ADDENDUM NO. 3

**PROJECT NAME: 2016-2017 TASK ORDER CONTRACT FOR MISCELLANEOUS
CONSTRUCTION PROJECTS PACKAGE 1 – 23-01472-05-03**

DATE: 3/10/2016

MISCELLANEOUS CONSTRUCTION STANDARDS I

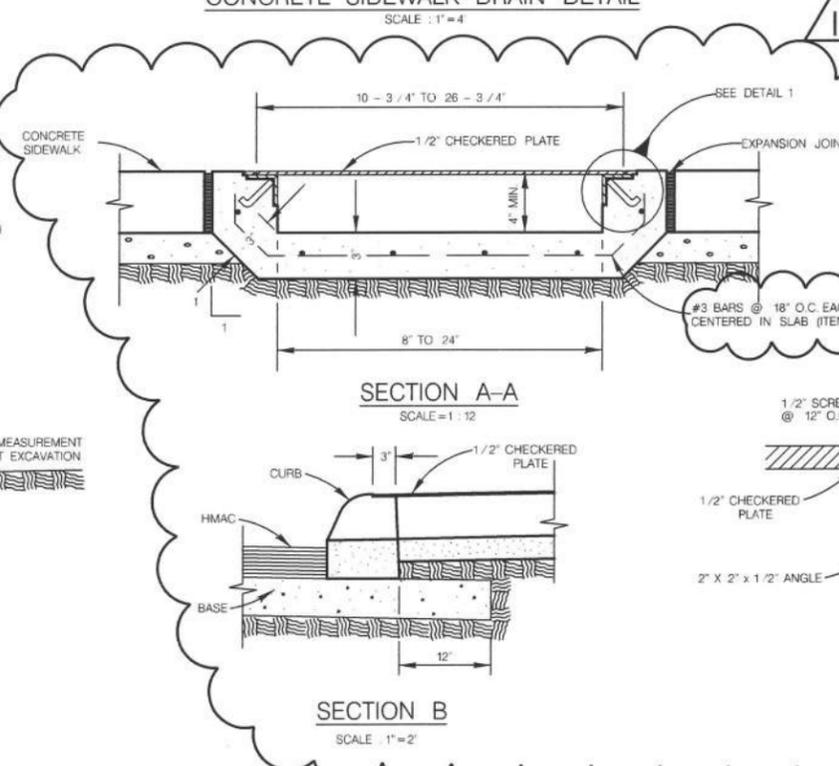
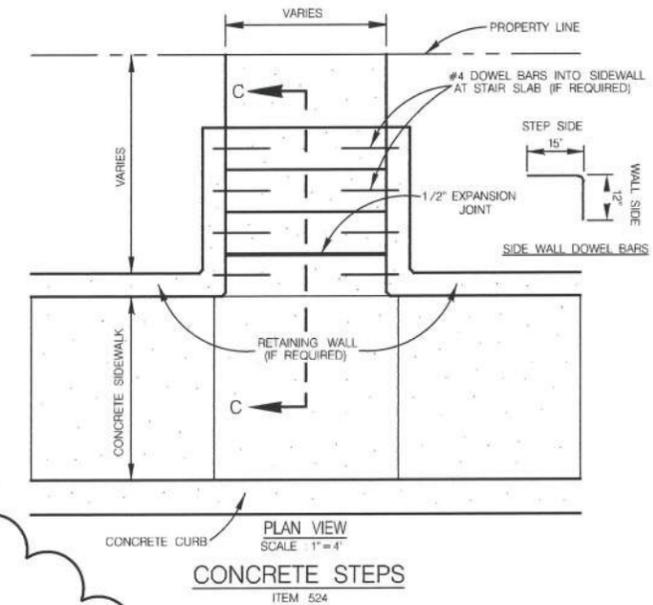
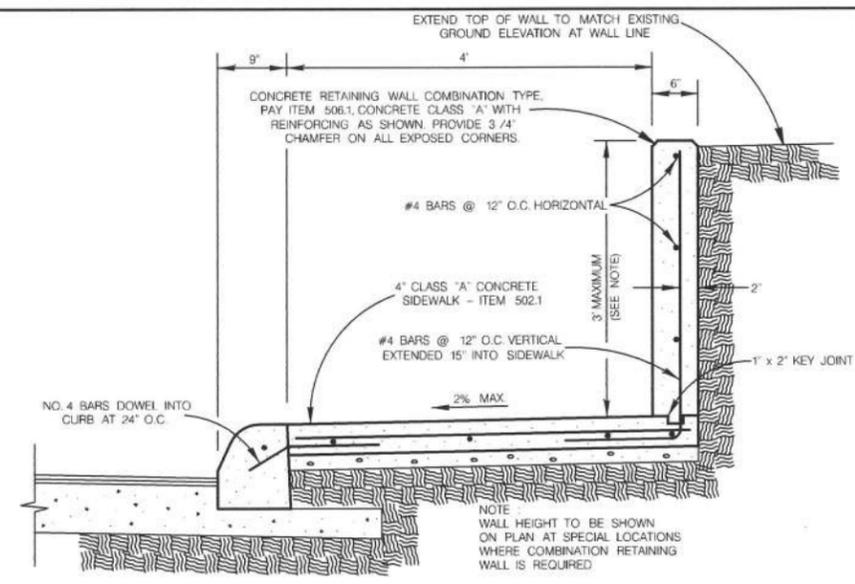
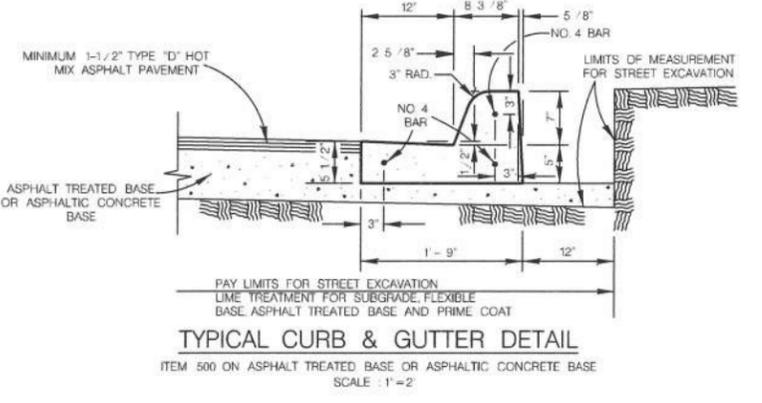
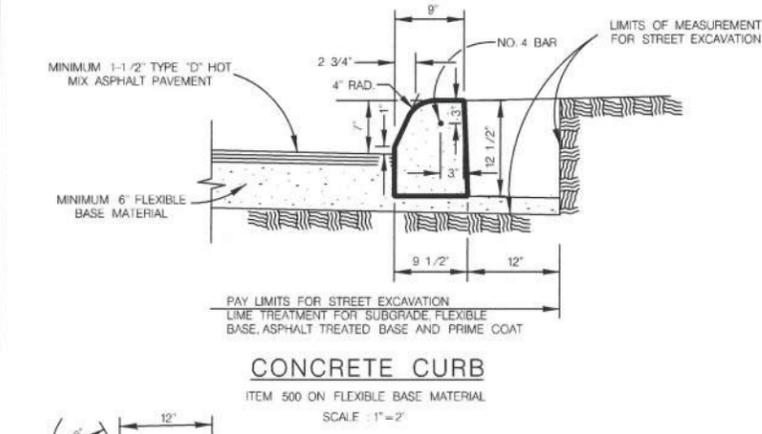
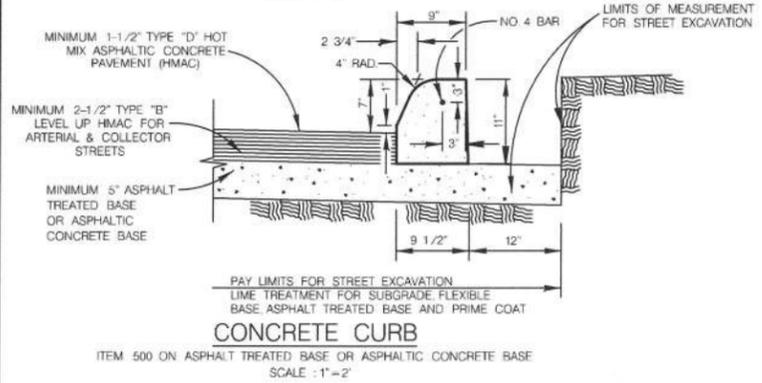
REV. NO.	DESCRIPTION	DATE
1	SIDEWALK DRAIN THICKNESS	2/18/16
2	BASE / REINFORCEMENT MODIFICATIONS	3/10/16

6" X 6" W/D 2.9 X W/D 2.9 welded wire flat sheets (Item 303) will NOT be allowed to be used as reinforcement for sidewalks. Contractor shall use No. 3 bars (minimum) @ 18 inches O.C. each way centered in slab as reinforcement for sidewalks.

CONCRETE DRIVEWAY STANDARDS

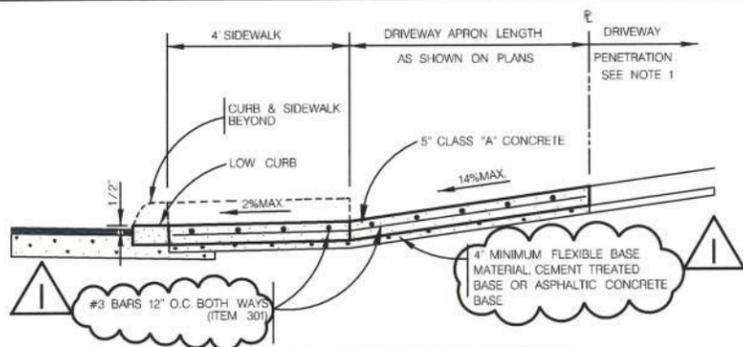
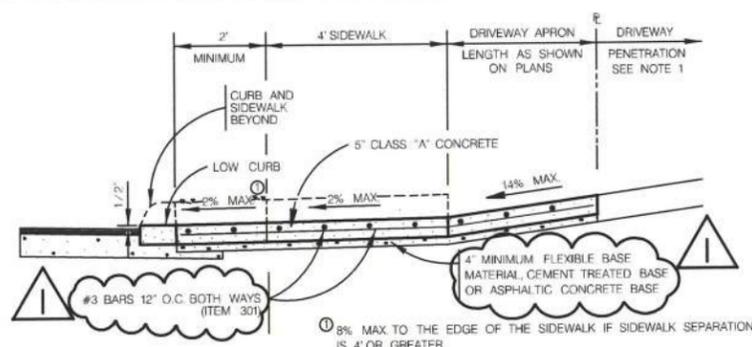
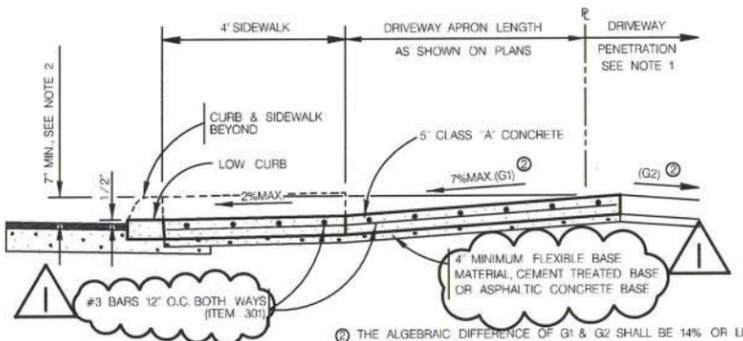
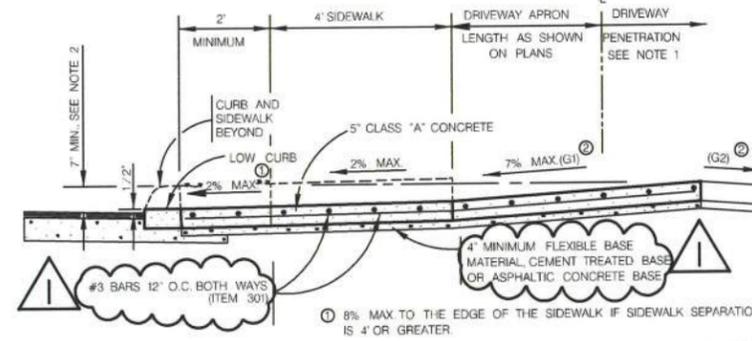
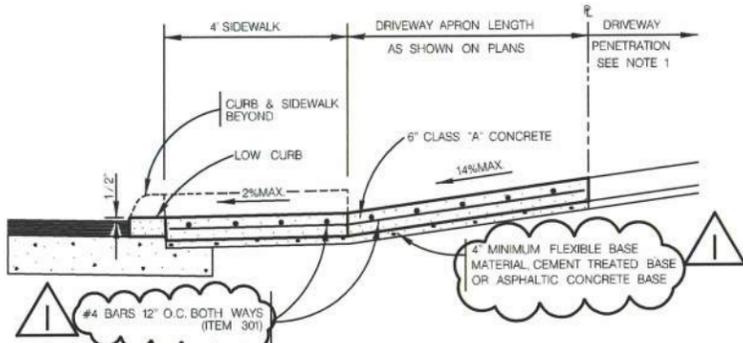
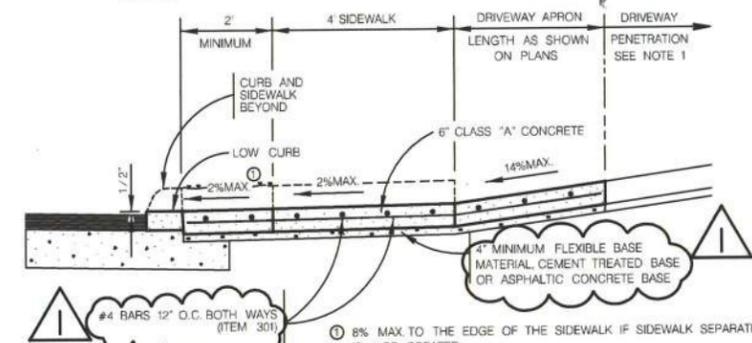
REV. NO.	DESCRIPTION	DATE
1	BASE / REINFORCEMENT MODIFICATIONS	3/10/16

A minimum section of 4" flexible base bedding will be required for installation of all driveways.

Reinforcing for commercial driveways shall consist of No. 4 (1/2") reinforcing steel placed not more than 12 inches on center both directions. Welded wire flat sheets will not be allowed to be used as reinforcement for commercial driveways. If existing reinforcement for commercial driveways is greater than No. 4 reinforcing steel, the contractor shall install equal reinforcing steel size. The concrete slab shall be a minimum of 6 inches thick or as shown on the plans. If existing slab thickness is thicker than 6 inches, the contractor shall match the existing thickness for the newly built driveway.
